63 VISTULA AVE, BELL PARK
RESIDENTIAL SUBDIVISION

project RESIDENTIAL SUBDIVISION

revision	date
rev. A	24.07.25
rev. B	24.08.05
rev. C	25.02.25
rev. D	30.06.25
AMENDMENT	30.06.26
RFI	03.07.26

ELEVATION 1
scale 1: 100 @ A3 sheet

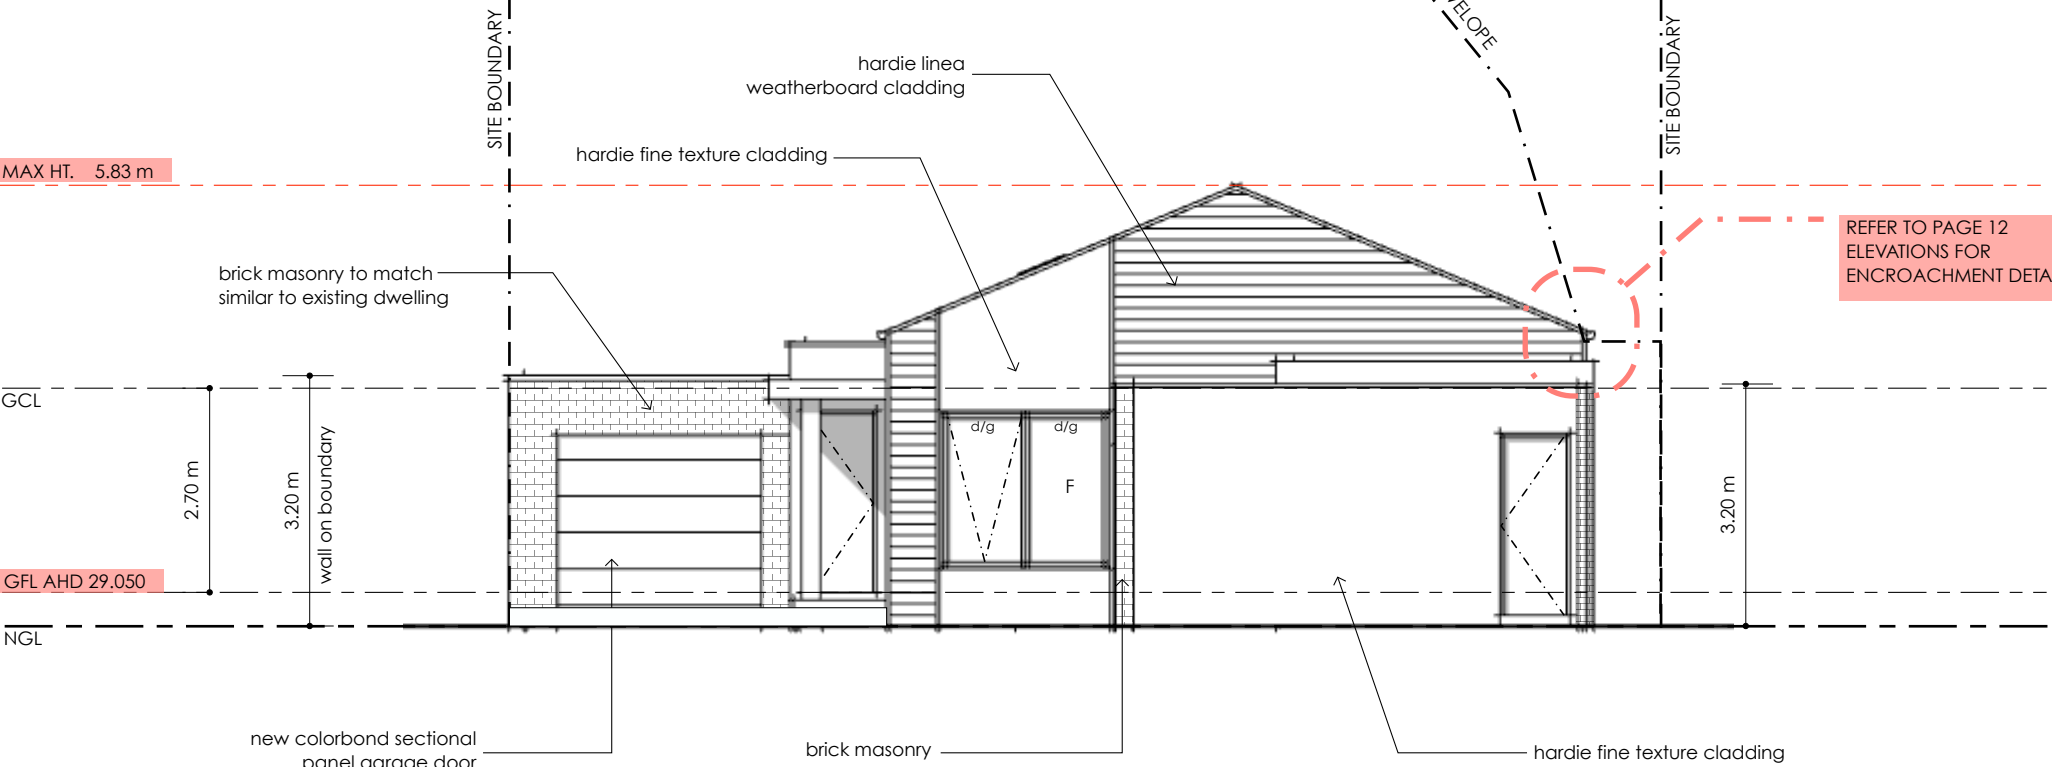
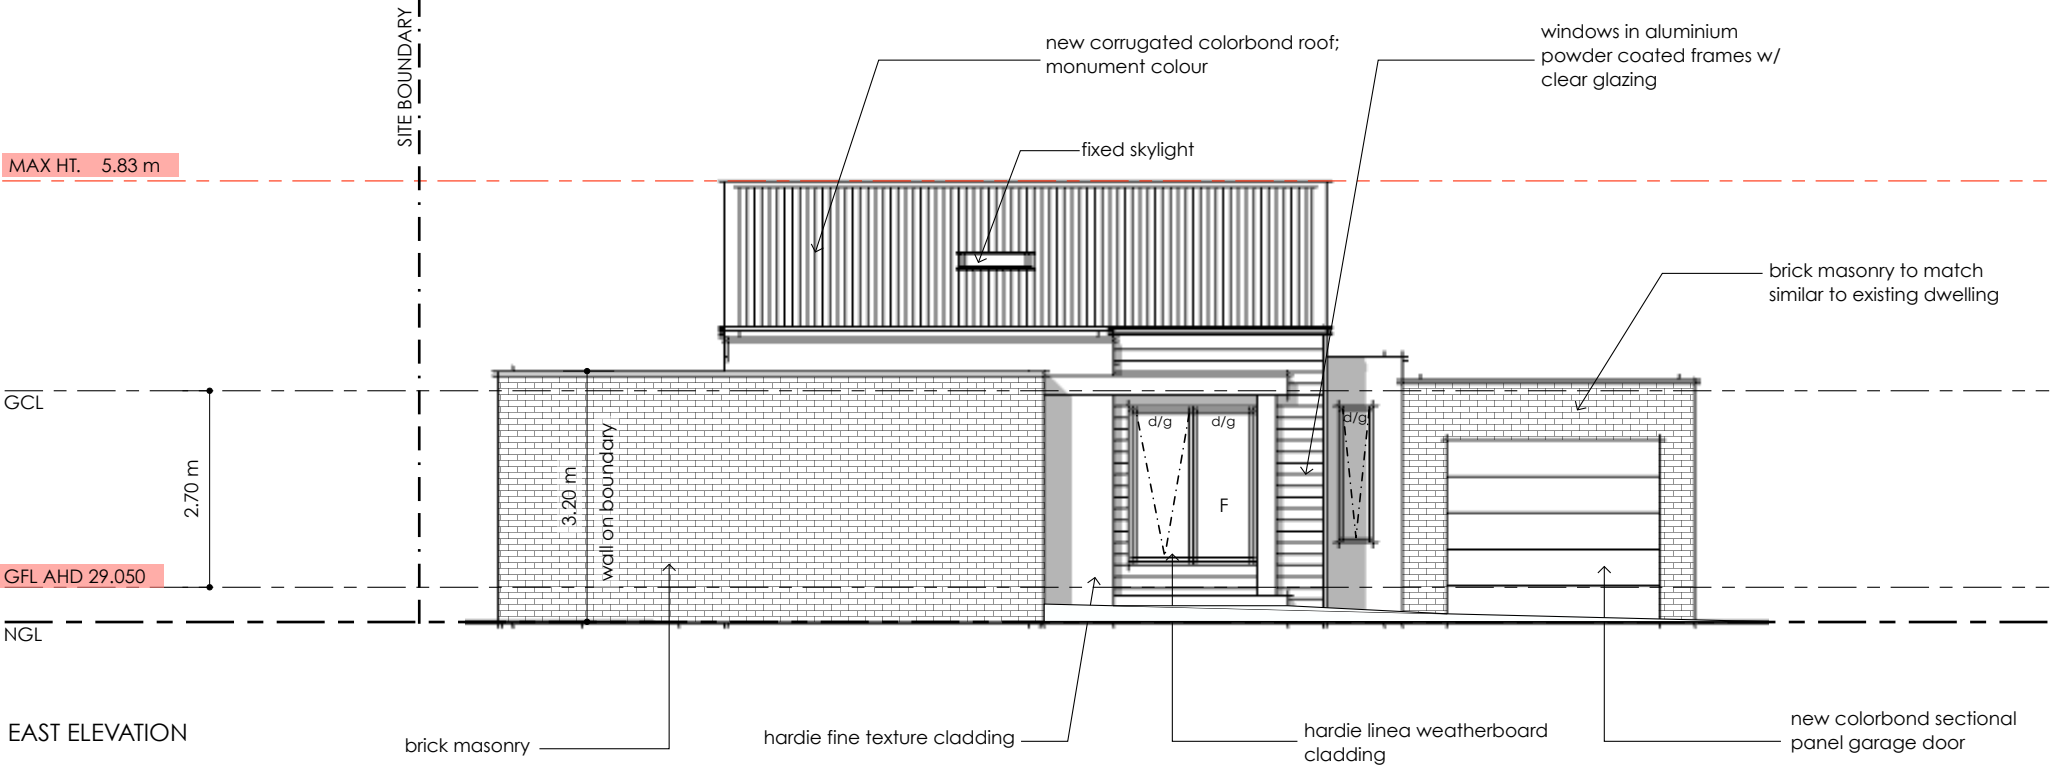
RFI 03.07.26
- GARAGE WALL ON BOUNDARY DIMENSION CONFIRMED AT 3.20m.
- EXTENT OF WESTERN WALL SIDE SETBACK ENCROACHMENT DETAILED
- WESTERN WALL HEIGHT CONFIRMED

AMENDMENT 30.03.26
- DWELLING 2 FINISHED FLOOR LEVEL AND OVERALL BUILDING HEIGHT RAISED TO COMPLY WITH BUILDING REGULATIONS FLOOD LEVEL REQUIREMENTS

ELEVATION 2
scale 1: 100 @ A3 sheet

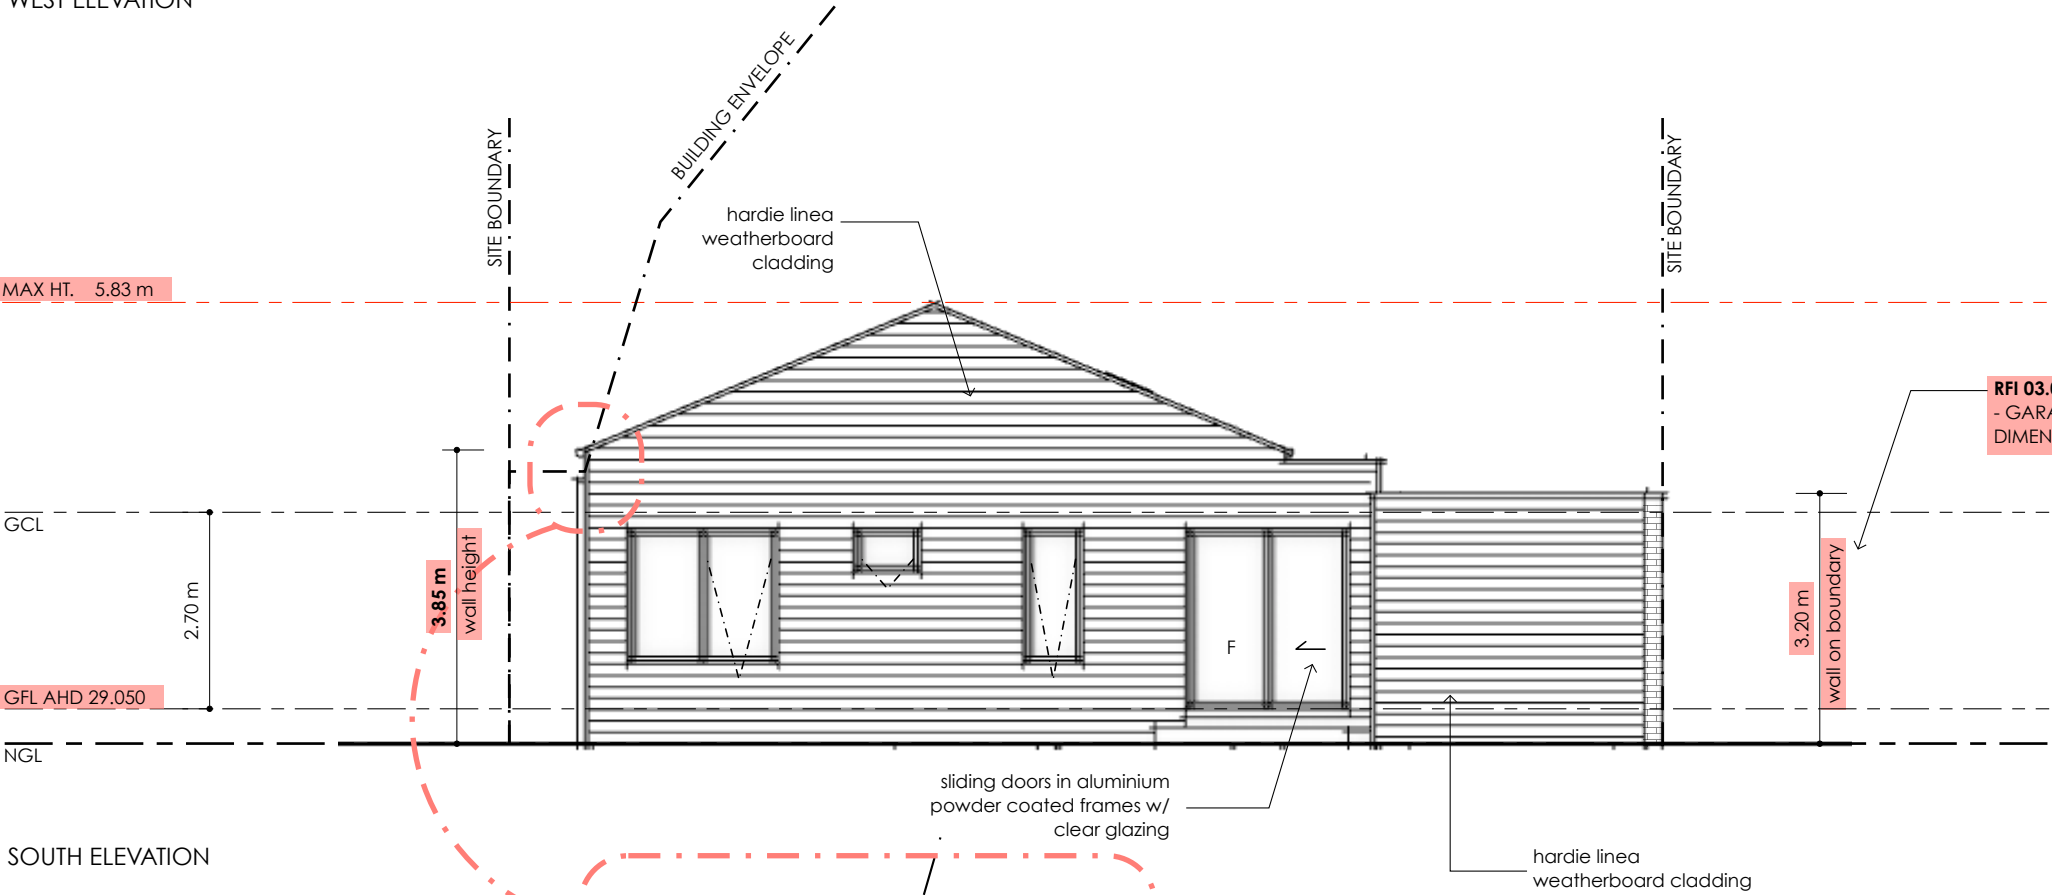
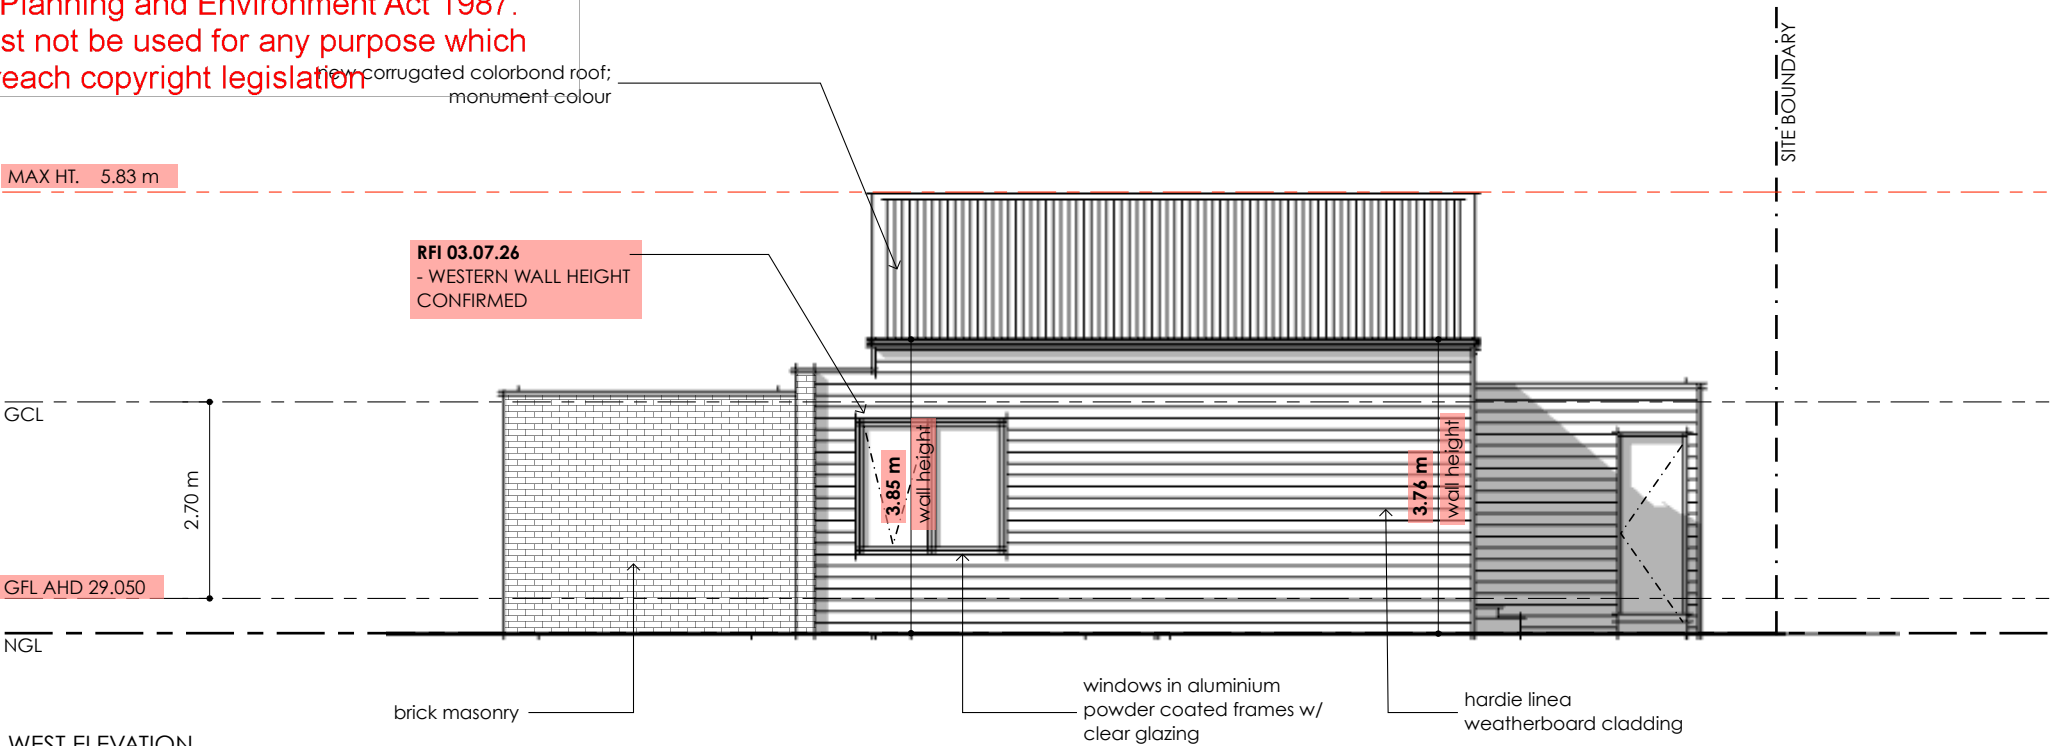
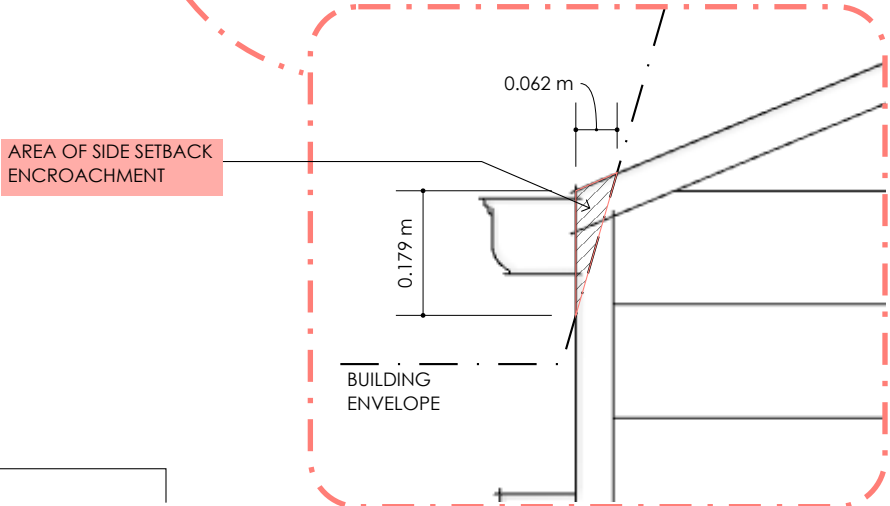
RFI 03.07.26
- GARAGE WALL ON BOUNDARY DIMENSION CONFIRMED AT 3.20m.
- EXTENT OF WESTERN WALL SIDE SETBACK ENCROACHMENT DETAILED
- WESTERN WALL HEIGHT CONFIRMED

AMENDMENT 30.03.26
- DWELLING 2 FINISHED FLOOR LEVEL AND OVERALL BUILDING HEIGHT RAISED TO COMPLY WITH BUILDING REGULATIONS FLOOD LEVEL REQUIREMENTS
